Greater Sudbury Hydro Inc

Interrogatory Response #2

School Energy Coalition

EB-2024-0026

Figure 18 GSHI 2007-2024 SAIFI Reliability Indices (Excluding Loss of Supply & Major Events)

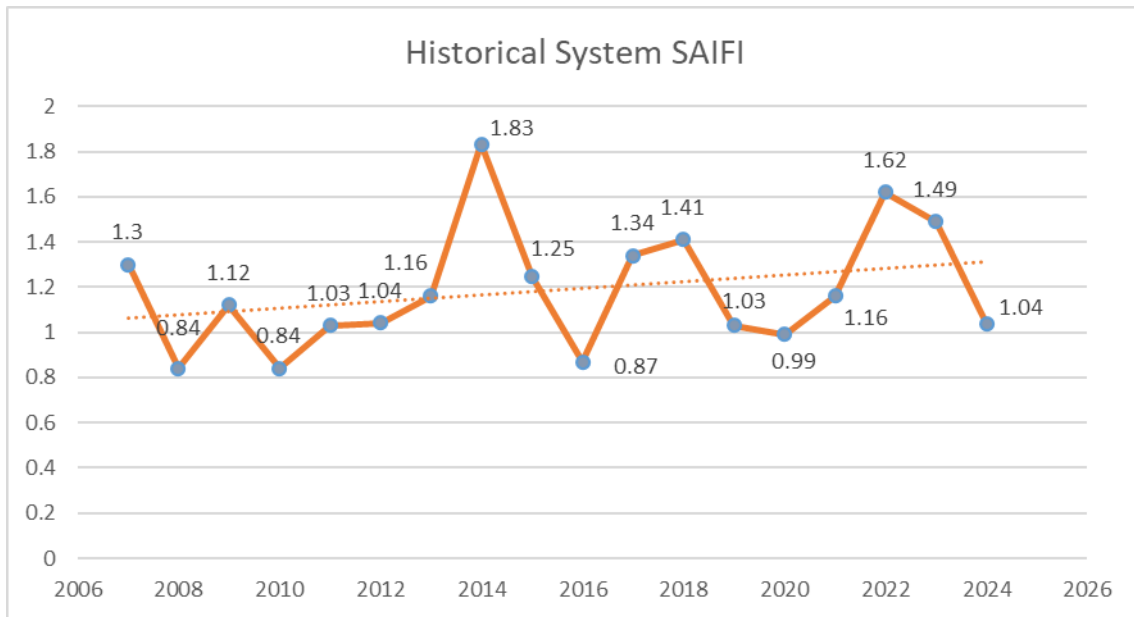
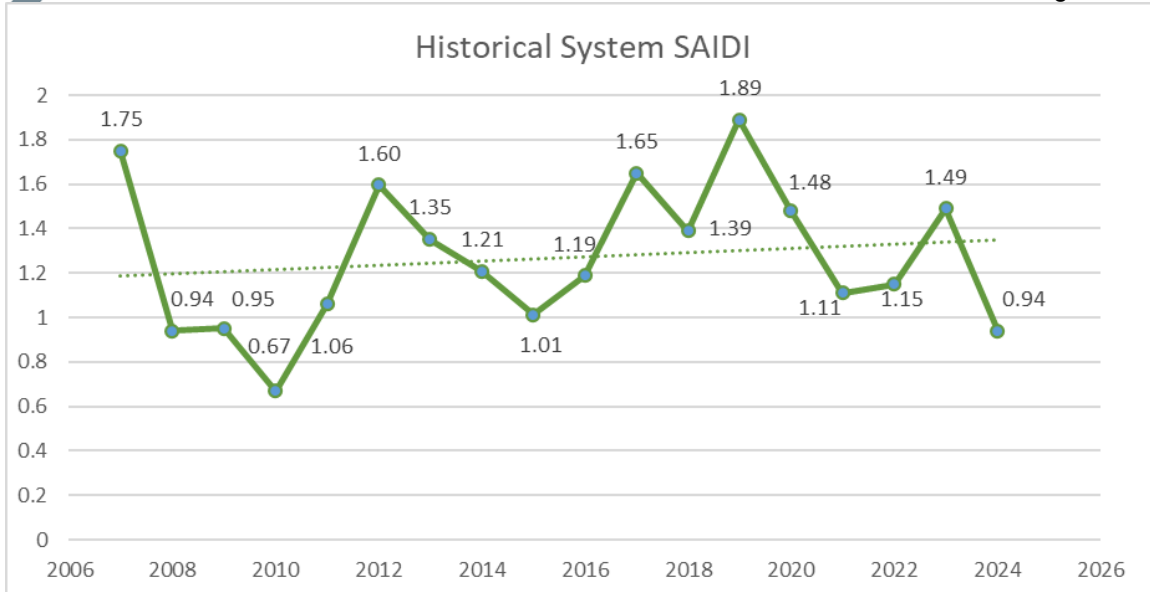
3 **[Ex.2-9]** Please provide updated versions of the following tables, figures and
4 appendices, to include 2024 actuals:

- 6 a. Tables 17, 18
- 7 b. Figures 18 and 19
- 8 c. Appendix 2-AA, 2-AB, 2-BA

b) Please see below for an updated version of both Figure 18 and 19 to include 2024 actuals:
